Re: Contract No. 200-2004-03805, Task Order 1: Transmittal of Draft Addendum to SCA-TR-TASK1-0003, *Status Report on the Resolution of the Savannah River Site Issues Resolution Matrix*

Status Report on the Resolution of the Savannah River Site Issues Resolution Matrix

Addendum to SCA-TR-TASK1-0003

Figure 4-1. Trends in SRS and Hanford Collective Neutron Dose Normalized to Plutonium Production

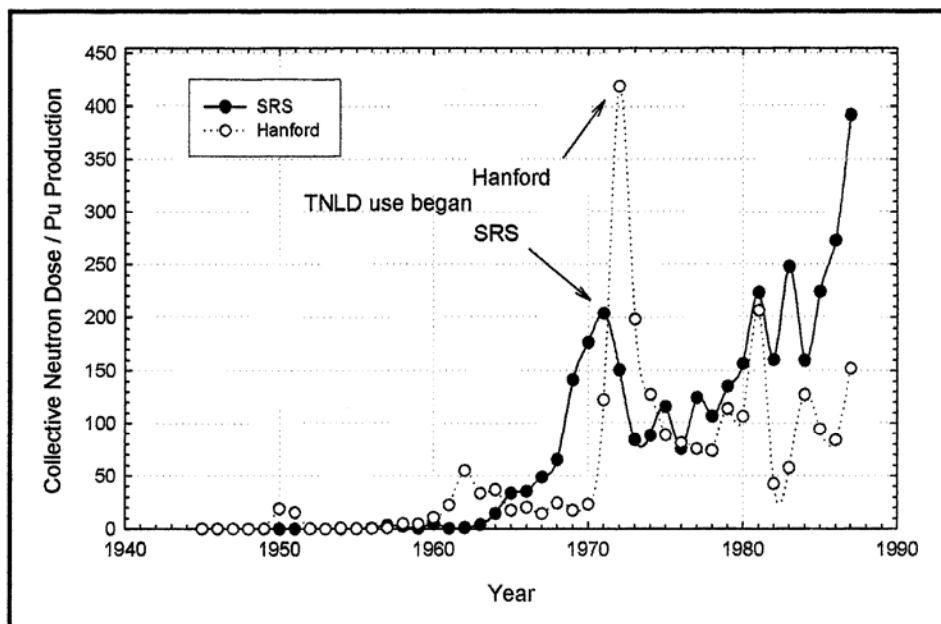
Figure 5.3.4.2-2 referenced above is reproduced below as Figure 4.1. Data shown in Figure 4.1 do not support either statement emphasized in the quotation above:

- At both SRS and Hanford, the rise in collective dose (supposedly standardized to plutonium production) began well before the advent of the TLND; and, in both cases, the standardized collective dose dropped precipitously after the implementation of the TLND with subsequent fluctuations.
- Because the collective neutron doses were standardized (i.e., defined in person-rem per unit quantity of plutonium), the observed oscillations clearly indicate that the collective dose is not correlated with or linked to plutonium production but may very well be the result of variations in neutron fields that surround work conditions in a given area and the variable response of the TLND.

Figure 4-2. Pu-239 and Np-237 Bioassay Comparison between Data in the Monthly Reports and Data Used for the High-Five Approach

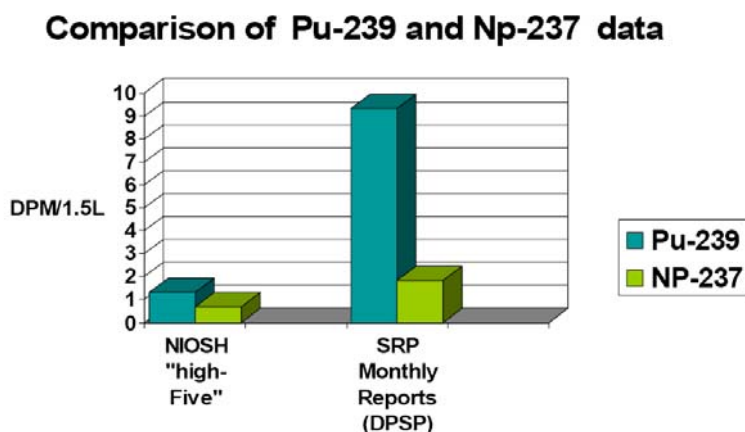
The above examples are only a fraction of the data identified from the DPSP monthly progress reports. Figure 4-2 depicts a synopsis of the bioassay data in the monthly reports versus those from individuals included in the high-five analysis for Pu-239 and Np-237. The monthly reports generally provide bioassay information up through 1965 that is higher than that observed for individuals represented in the high-five analysis. The monthly progress reports accessible to SC&A were available only through 1965 for this analysis.
